STAFF RECOMMENDATION

NCPC File No. 6972

LINCOLN MEMORIAL GROUNDS AND WEST POTOMAC PARK REHABILITATION AND PERIMETER SECURITY

August 27, 2009

Current conditions: Plan showing HISTORIC (RED) and NON-HISTORIC (BLUE) path circulation system. Outside of the rectilinear paths and stairs in the central Mall axis (RED), the circulation plan has been altered since the Memorial and Reflecting Pool were completed in the 1920s.

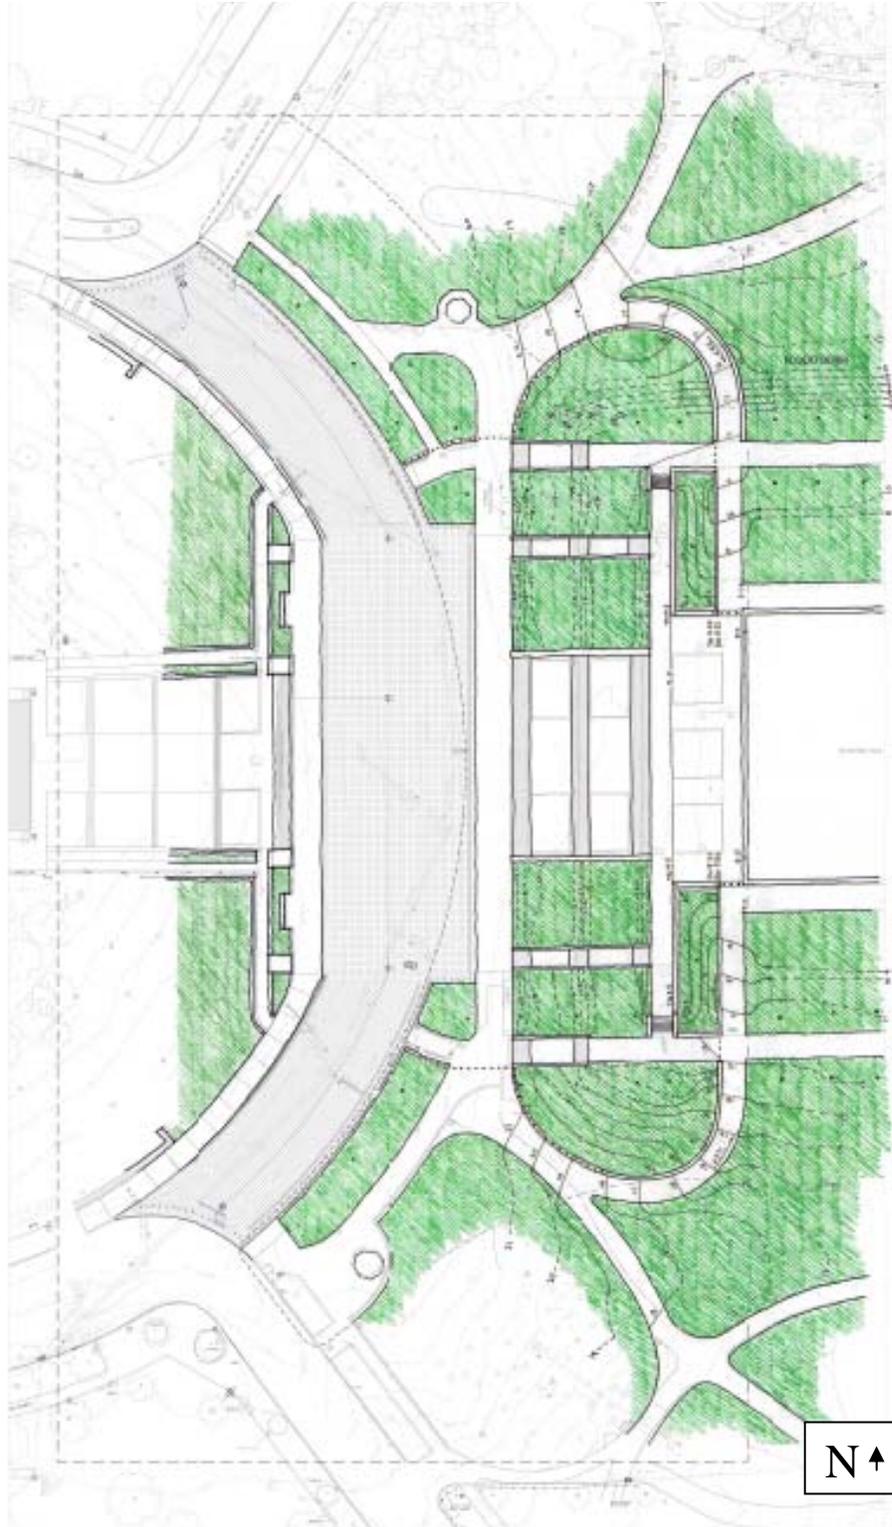
As shown in the plan, below, new north-south paths would be created at the western edge of the Reflecting Pool. Existing paths that cross the Elm Walks would be modified. (New accessible paths are shown in ORANGE and new stairs to modify the existing path are shown in PURPLE.)

The annotated plan on page 5 illustrates two proposed new stairs, highlighted in purple. The stairs, designed to be similar to the stairs of the lower approach way, would constitute a modification of the existing paths and would provide a formal transition to the higher grade of the Elm Walks. The stairs also would allow for a more finished appearance to the retaining walls

The proposed provision for the first time of full accessibility to all visitors is a significant achievement of the proposed plan. The new paths are shown in orange on page 5 of this report. Combining the new paths, which do not exceed a 5% slope and therefore do not require handrails, with the vehicle barrier is a more natural way of introducing the barrier into the landscape. The barrier along the edge of the new paths will likely be a combination of seating walls and bollards, as shown in the perspectives illustrating this report. The design team is continuing to study the design.

The proposed circulation and security plan, with north oriented to the top of the page and west to the left.

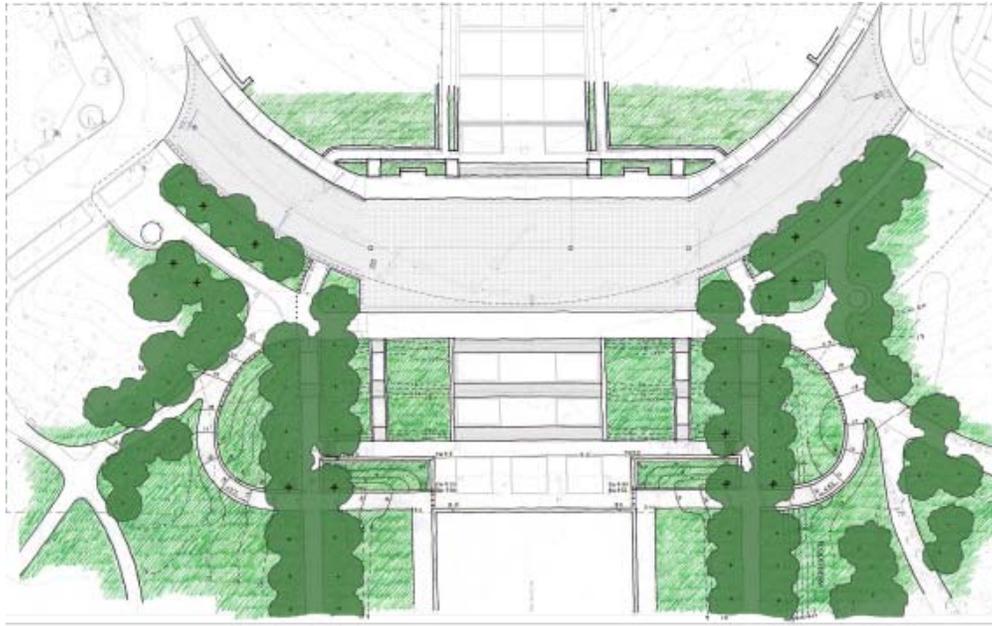
The use of several bollards across paths is required by this scheme. The bollards are indicated with dots in the plan on page 6 of this report. One advantage of this scheme over earlier proposals, however, is that the bollards immediately to the west of the Reflecting Pool are aligned parallel to the long sides of the pool rather than perpendicular to the pool, so they will be less visible in axial views than if they were crossing the east-west axis. Bollards are also required across the Elm Walks in one location on each walk.
